**From:** Sami Malaeb [s.malaeb@comcast.net]  
**Sent:** Friday, February 14, 2014 5:00 PM  
**To:** Detterman, Mark, Env. Health; britpete@aol.com  
**Cc:** Roe, Dilan, Env. Health; LGRIFFIN@OAKLANDNET.COM; rbatiste@eec-corp.com  
**Subject:** RE: Chevron 98861 (Independent); 2145 35th Avenue, Oakland, (RO2945)  
**Attachments:** Figure 1 Future Site Plan.pdf; Figure 2 Future Site Plan and Depiction of TPHG and TPHD in Soi (02.14.14)l.TCT.pdf

Alameda County Environmental Health (ACEH) staff has reviewed the case file for the above referenced site including the *Soil and Groundwater Investigation Report*, dated November 12, 2013, (received November 25, 2013), and the *Semi-Annual Groundwater Monitoring Report, Fifth Sampling Event, December 2013*, dated December 23, 2013. The reports were prepared and submitted on your behalf by Eagle Environmental Construction (EEC). Thank you for submitting the reports. The investigation report documented the installation of soil bores BH-16 to BH-25 that appear to have defined the downgradient and lateral extent of the soil and groundwater plume, and evaluated the site against the Low-Threat Closure Policy (LTCP). The report found that the site

FIGURE 1  
FEBRUARY 2014

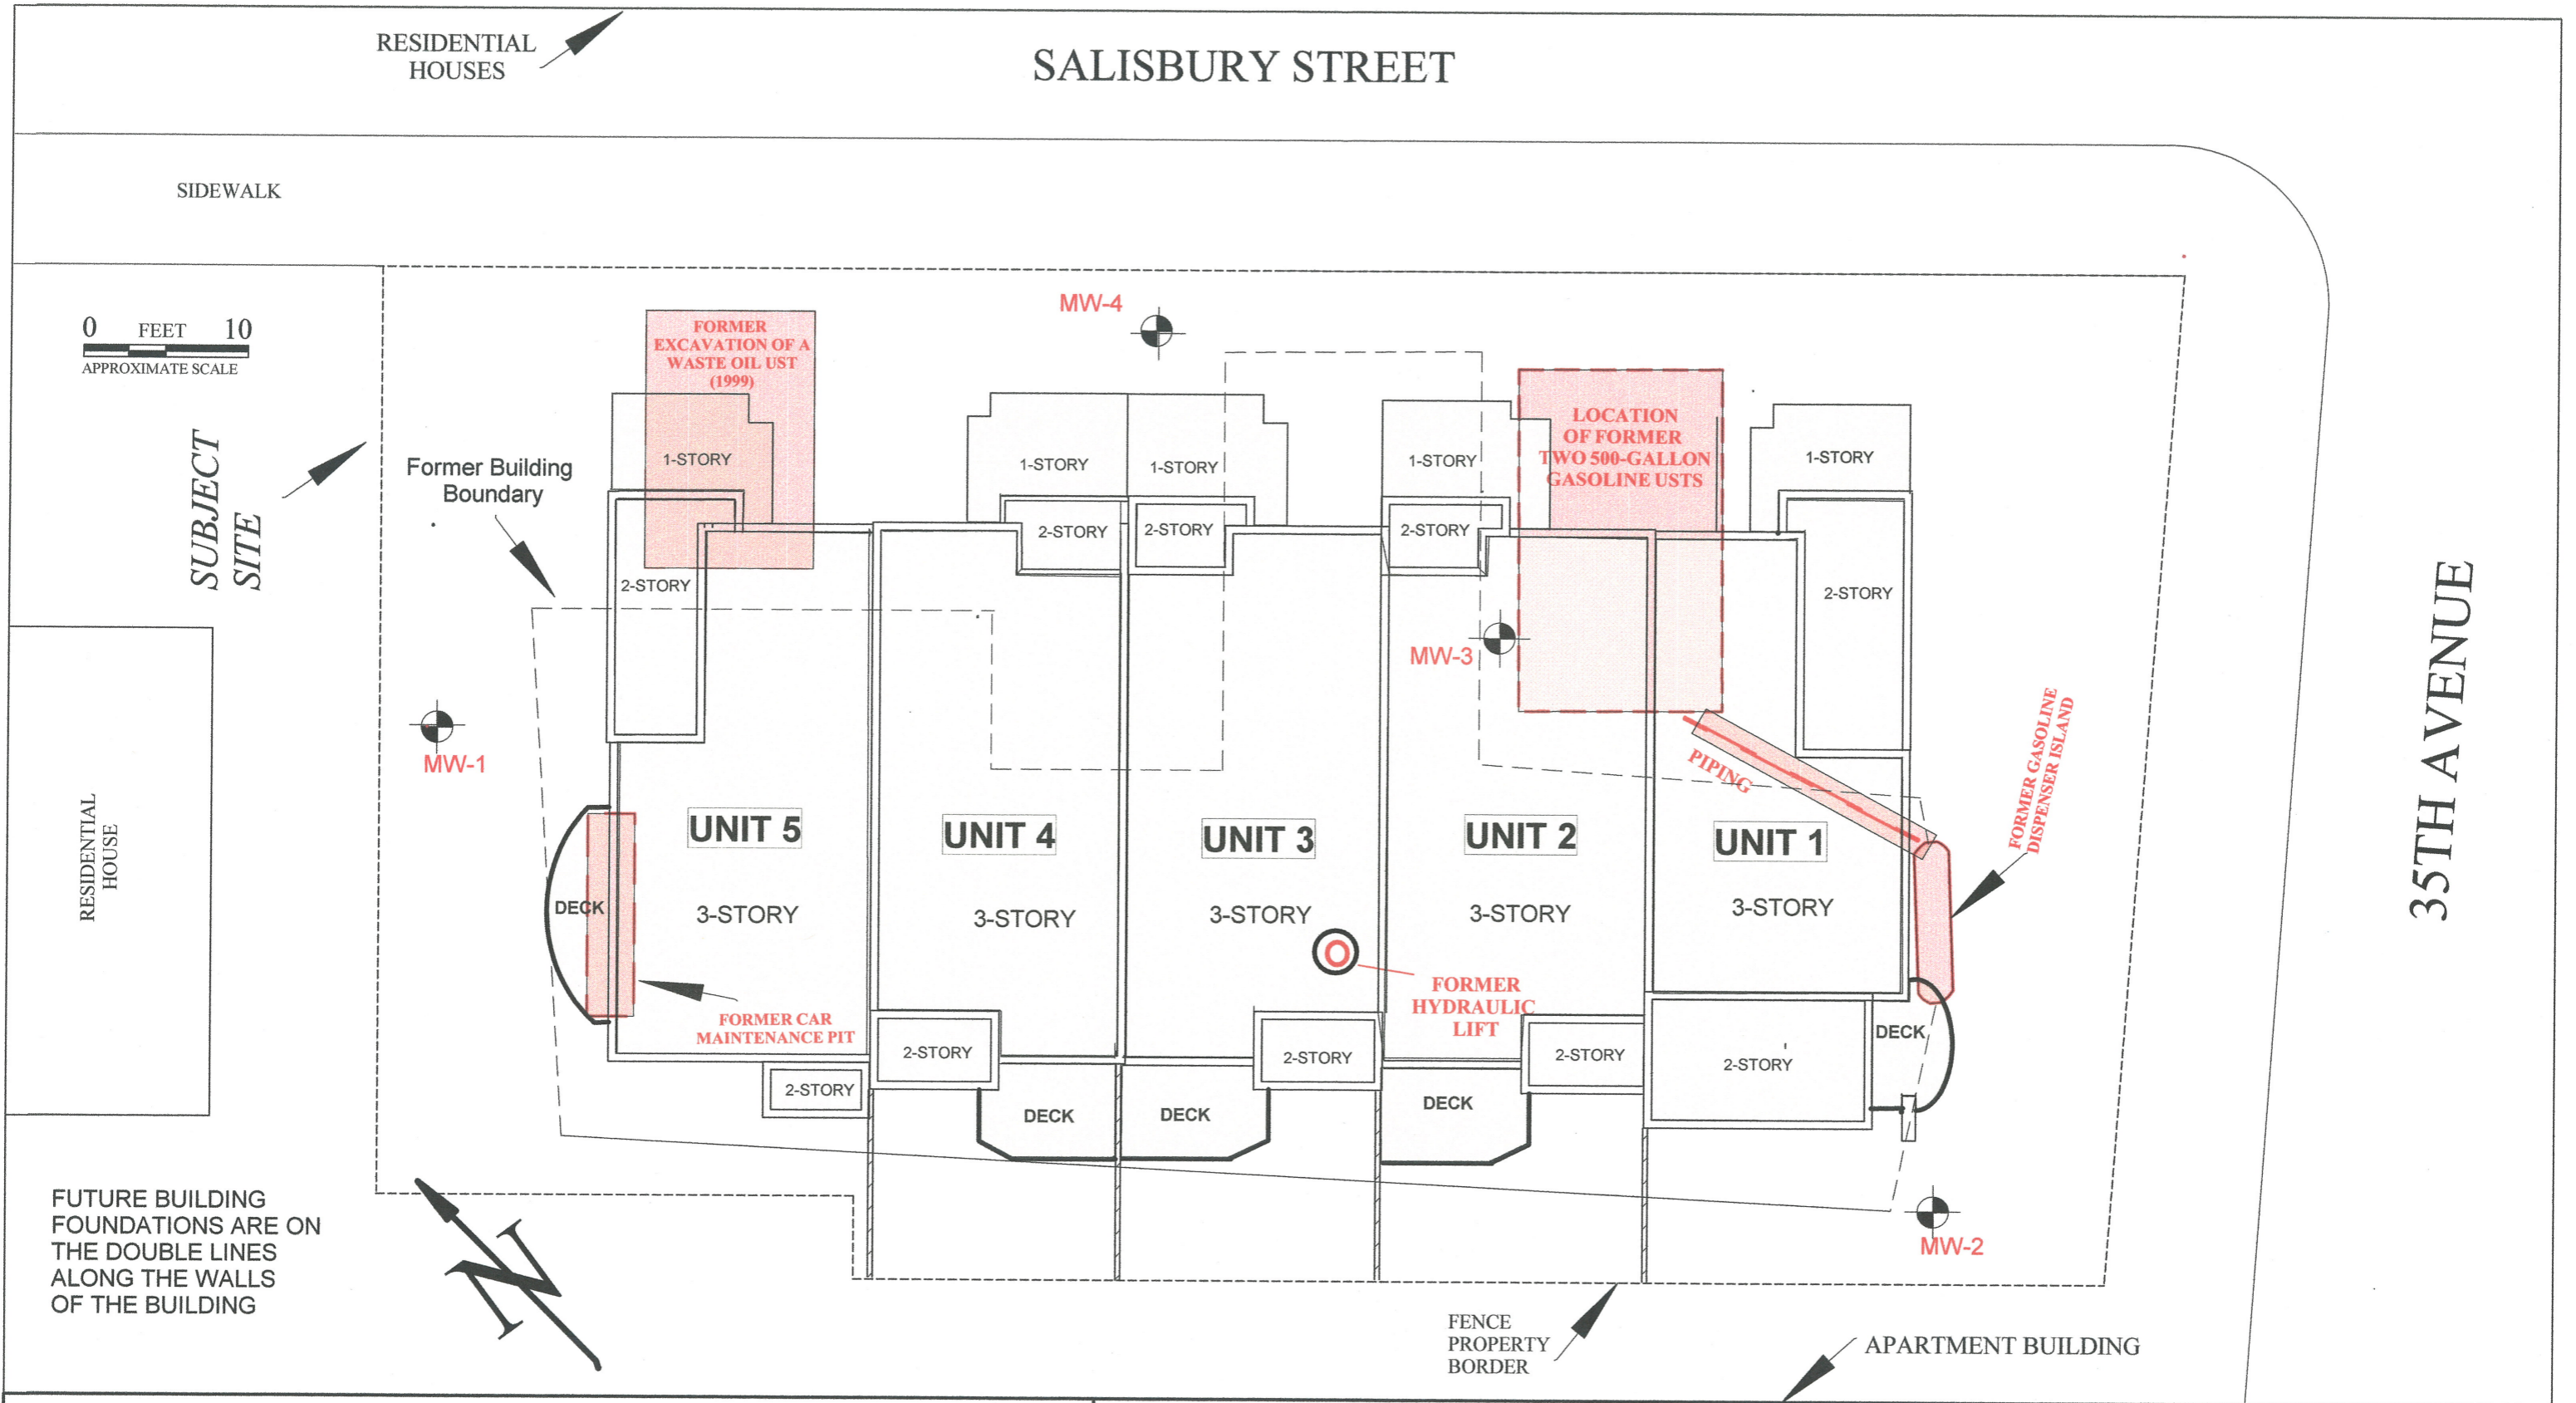
- b. Additional Site Figures** – Prior to the requested meeting, ACEH requests the submittal of a figure that depicts the location of the future residential building features on to a figure that also depicts former site use areas, and site soil bores, wells, and etc. in order to help facilitate an understanding of the juxtapositioning of past and future uses of the site, and identification of areas of potential concern. ACEH also requests a site plan figure depicting the foundation trench excavation plan overlain on to former use areas, and site soil bores, wells, and etc. ACEH also requests a cross-sectional figure depicting proposed building excavation areas (foundation trench, elevator, or other excavation) overlain on former use areas, and soil or well bore analytical data (especially soil data). Finally, the generation of a conceptual Proposed Soil Excavation Areas figure will also be of assistance in this process.

Figure 1 – Shows the planned five units and foundations, superimposed on the features of the site.

FIGURE 3  
FEBRUARY 2014

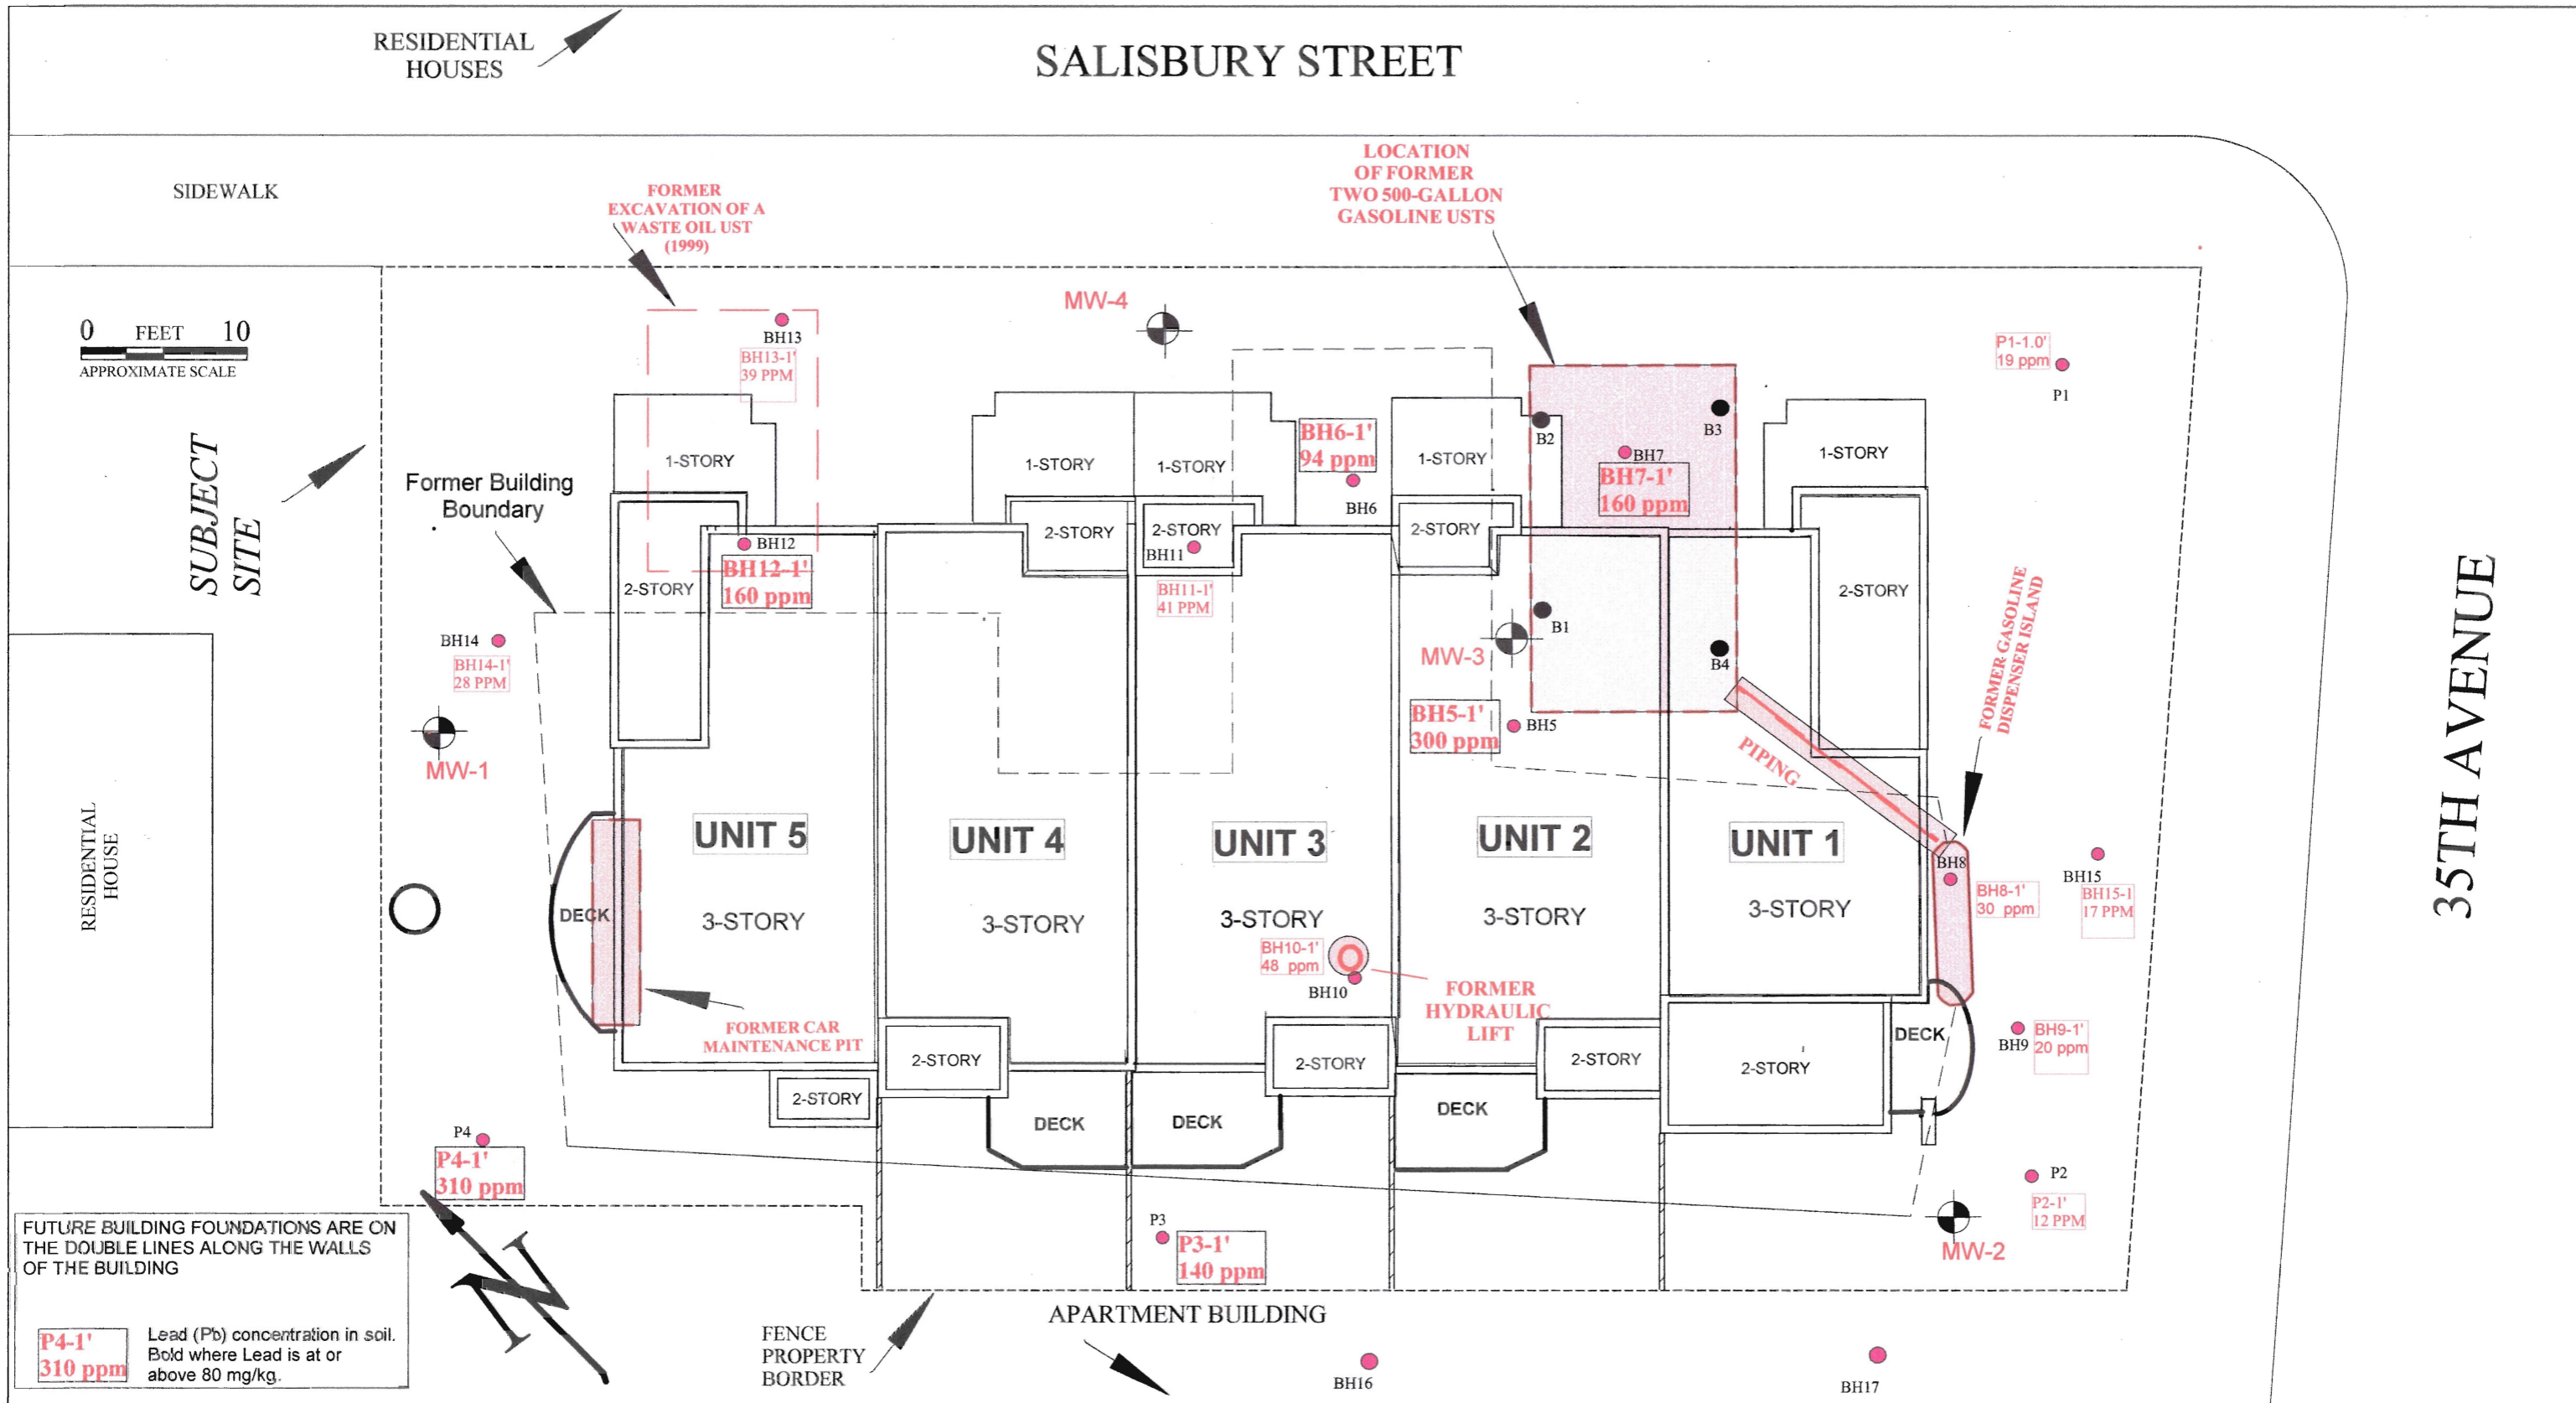
- 2. Lead Contamination** – The referenced report utilized a HUD cleanup goal of 400 milligrams per kilogram (mg/kg) for lead. Please be aware that the Regional Water Quality Control Board (RWQCB) Environmental Screening Level (ESL) for lead is currently 80 mg/kg for residential properties unless an alternative evaluation of risk has been conducted.

Figure 3 - Shows the Lead (Pb) concentrations in shallow soil.
